Date: November 19, 2025
To: Jack Ward
Quieter Home Program, Manager of Field Activities
From: Patrick Leroy
The Jones Payne Group, Inc.
Subject: RES # 381408.45
Hidalgo Residence at 1261 34th Street Unit 28, San Diego, CA 92102
Job No: Group 14.8
Cc: Design Team: JPG, HAP & PBS

ASSESSMENT REPORT:

NOTIFICATIONS, PRE-WORK AND BUILDING CODE OBSERVATIONS

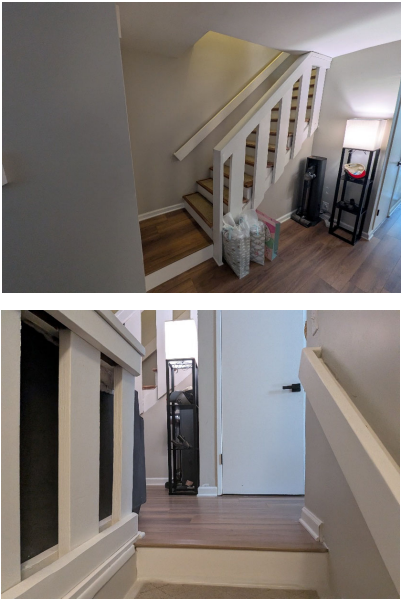
PHOTO AND LOCATION:	ISSUE:	RECOMMENDATION:
1. GUARD RAILS AT STAIRS 	1. NON-CODE COMPLIANT GUARD RAILS THE DESIGN TEAM OBSERVED MISSING OR NON-COMPLIANT GUARD RAILINGS. (LESS THAN 42-INCHES & GREATER THAN 4-INCHES)	1. NOTIFICATION: THE EXISTING GUARD RAILS WILL REMAIN IN PLACE WITH NO WORK BY THE QUIETER HOME PROGRAM AT THIS LOCATION. THE HOMEOWNER SHOULD CONSIDER CORRECTING THIS CONDITION BY PROVIDING CODE COMPLIANT GUARD RAILINGS. NO PREWORK REPAIRS ARE REQUIRED AT THIS TIME FOR PARTICIPATION IN THE QUIETER HOME PROGRAM. NOTE: THE BUILDING CODE REQUIRES GUARD RAILS AT ALL WALKING SURFACES (INCLUDING STAIRS, LANDINGS, BALCONIES AND DECKS), THAT ARE GREATER THAN 30 INCHES ABOVE GRADE OR THE ADJACENT FLOOR. GUARD RAILS MUST BE AT LEAST 42-INCHES IN HEIGHT EXCEPT AT STAIRS WHICH MUST BE AT LEAST 34-INCHES IN HEIGHT. SPACES AT GUARD BALUSTRADES OR BETWEEN OTHER MEMBERS SHALL NOT ALLOW THE PASSAGE OF A 4-INCH DIAMETER SPHERE.

SPECIAL CONDITIONS : SK-A

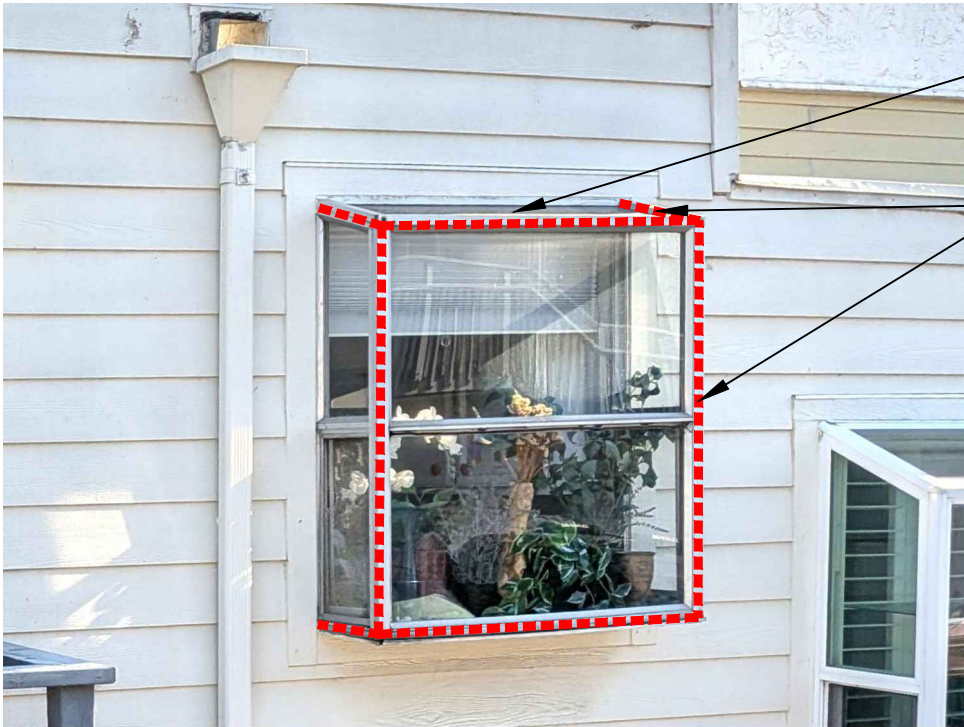
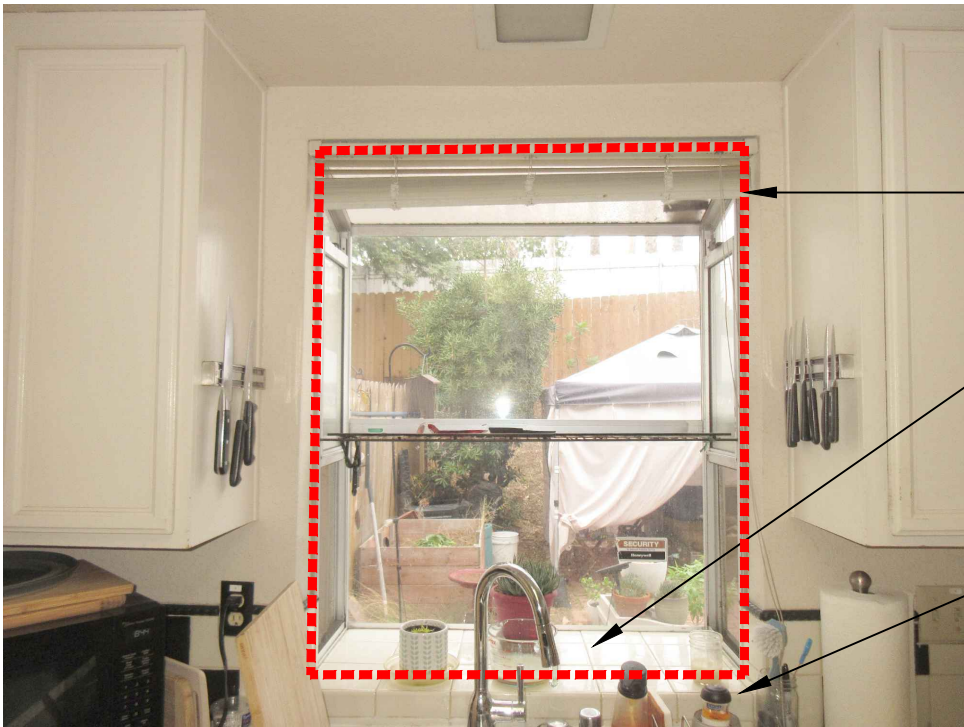
CUT AND REMOVE EXTENDED GARDEN WINDOW AND RETAIN EXISTING ALUMINUM FRAME AT OPENING

CUT BACK EXISTING TILE/STONE TO ALLOW INSTALLATION OF NEW WINDOW

EXISTING TILE/STONE STOOL AND/OR SURROUNDING TO REMAIN
